NZ 163/05 NEW ZEALAND – North and South Islands – Lights.

Land Information New Zealand
 NZ Light List K3713, 3954, 3998, 4286, 4364, 4376, 4380, 4470
 NI 143/2005

Chart NZ 5214 [53/05] (On certain copies only)

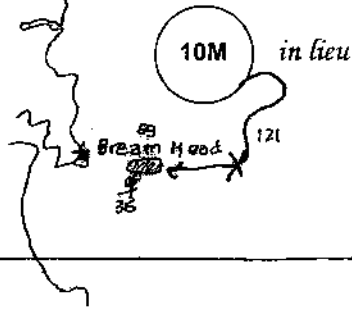
Amend light range to, 10M 35° 50'.67S 174° 34'.87E.

LAST CORRECTION	NZ NTM No.	CHART No.
NF Apr 05	NZ 163/05	NZ 23 (INT 640)

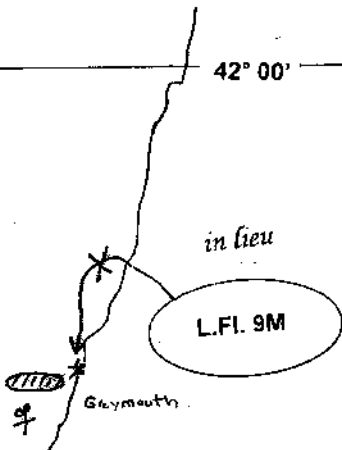
Amend light range to, 10M 35° 50'.7S 174° 34'.9E.
 38° 42'.1S 178° 03'.9E.
 light to, *L.Fl.* 10M 41° 20'.6S. 175° 49'.6E.
 light to, *L.Fl.* (3) 17M 43° 35'.2S. 172° 48'.5E.
 light to, *L.Fl.* 9M 42° 26'.4S., 171° 11'.5E.

L.FI. (3) 17M

L.FI. 10M

LAST CORRECTION	NZ NTM No.	CHART No.
NE Apr 05	NZ 163/05	NZ 25 (INT 648)

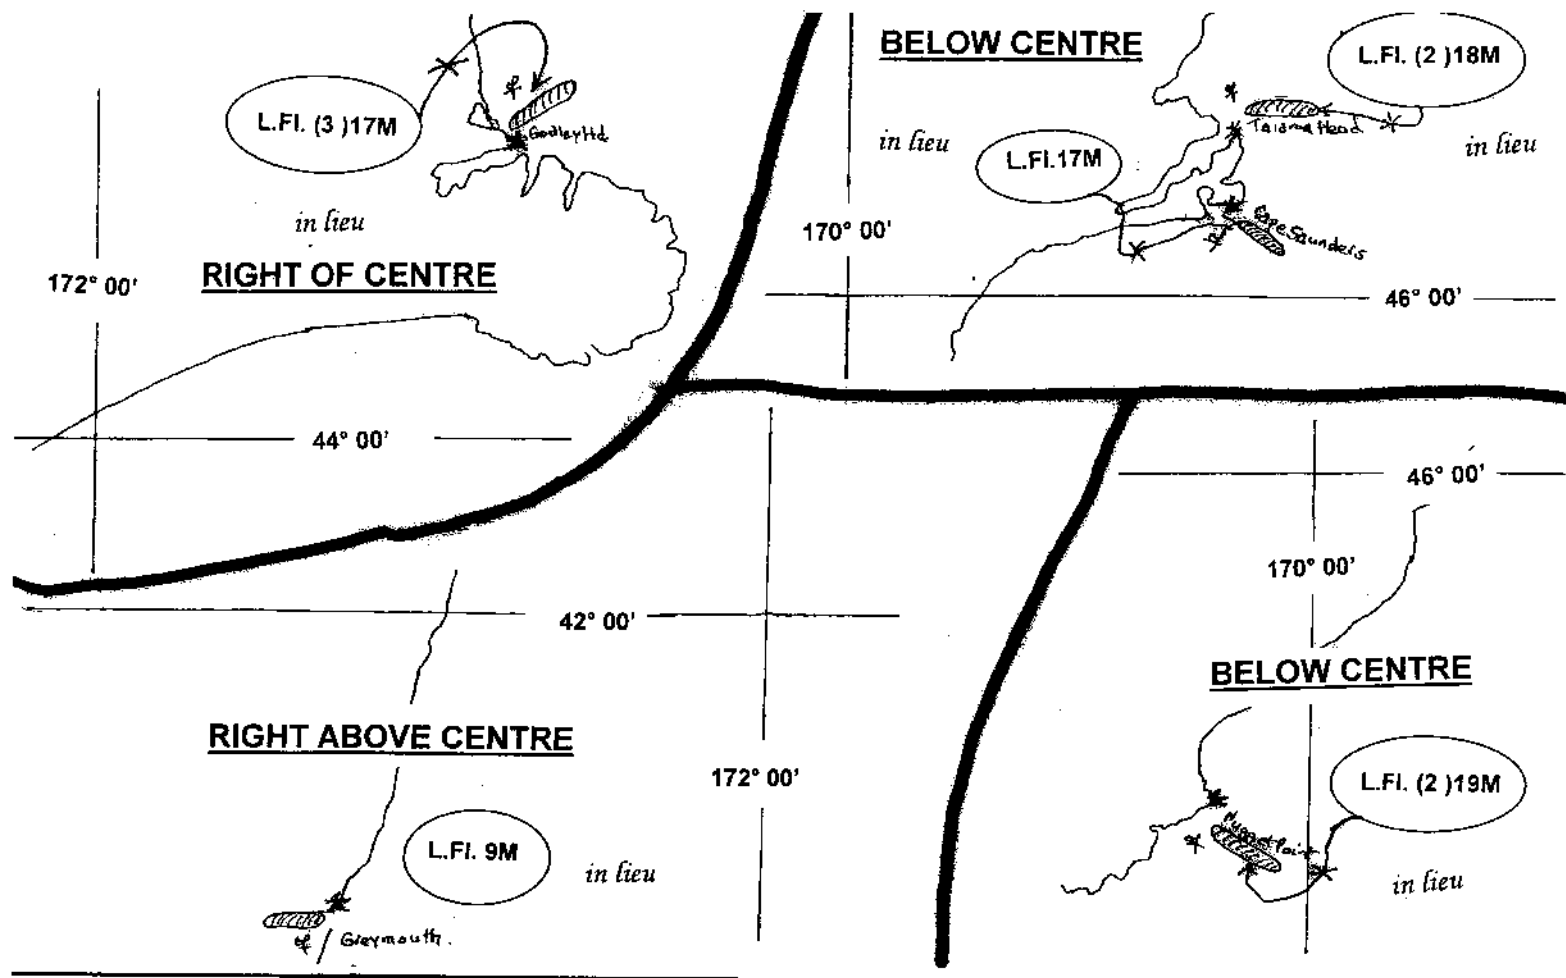
Amend light to, *L.Fl.* (3) 17M 43° 35'.2S. 172° 48'.5E.
 light to, *L.Fl.* (2) 18M 45° 46'.4S., 170° 43'.7E
 light to, *L.Fl.* 17M 45° 52'.8S., 170° 43'.7E
 light to, *L.Fl.* (2) 19M 46° 26'.9S., 169° 49'.0E.
 light to, *L.Fl.* 9M 42° 26'.4S., 171° 11'.5E.

LAST CORRECTION	NZ NTM No.	CHART No.
NE Apr 05	NZ 163/05	NZ 26

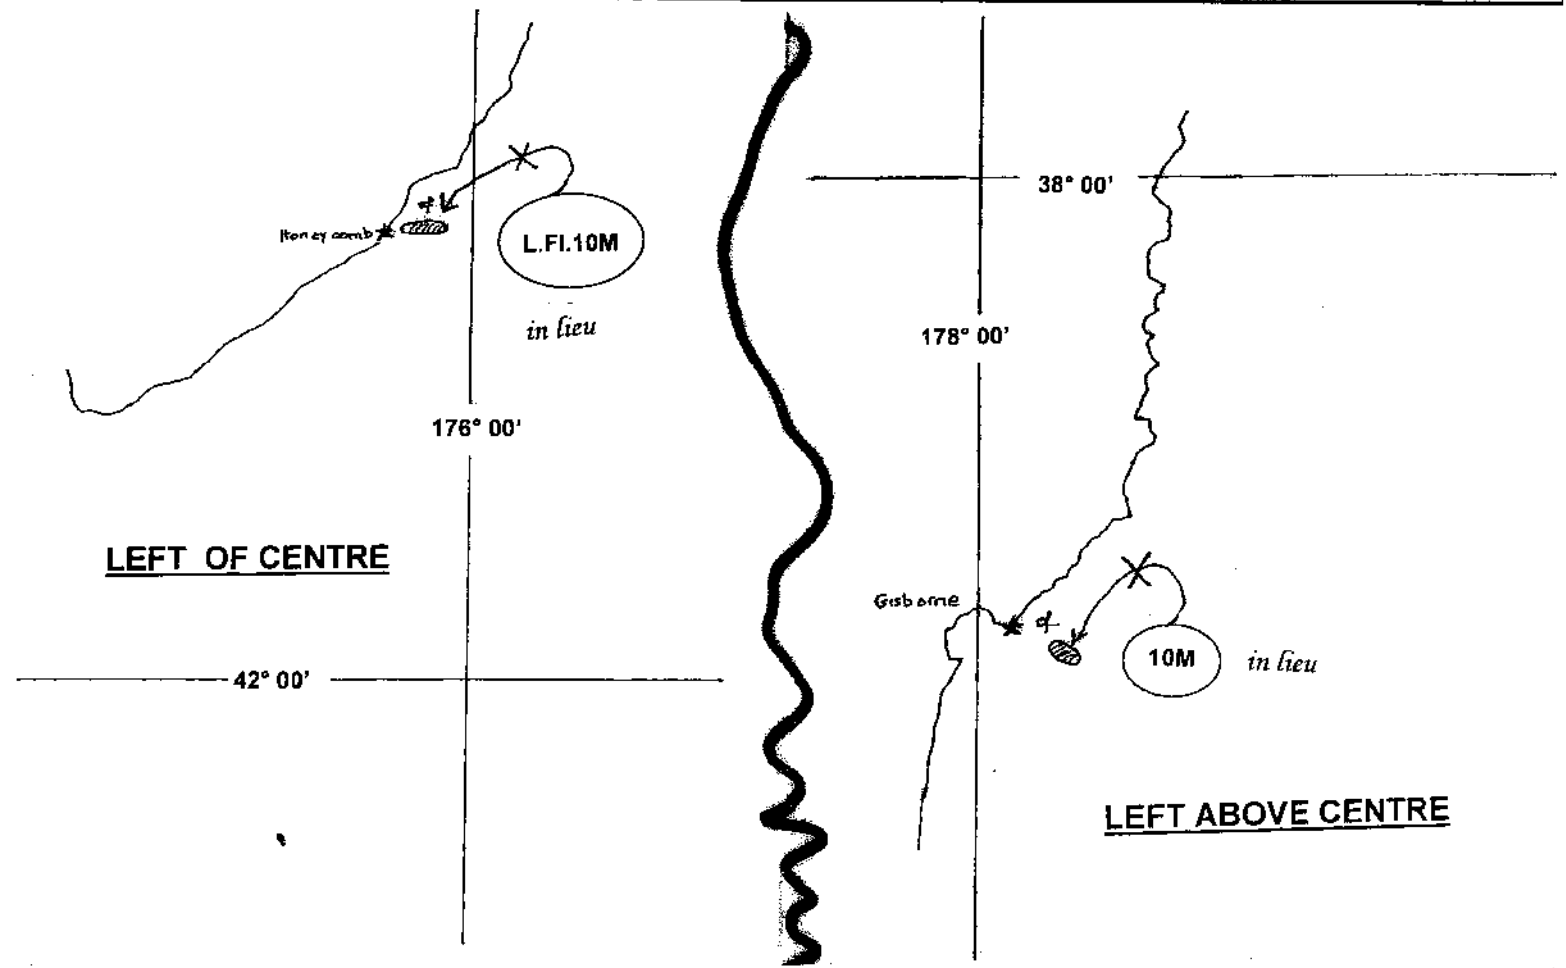
Amend light range to, 10M 38° 42'.1S 178° 03'.9E.
 light to, *L.Fl.* 10M 41° 20'.6S. 175° 49'.6E.
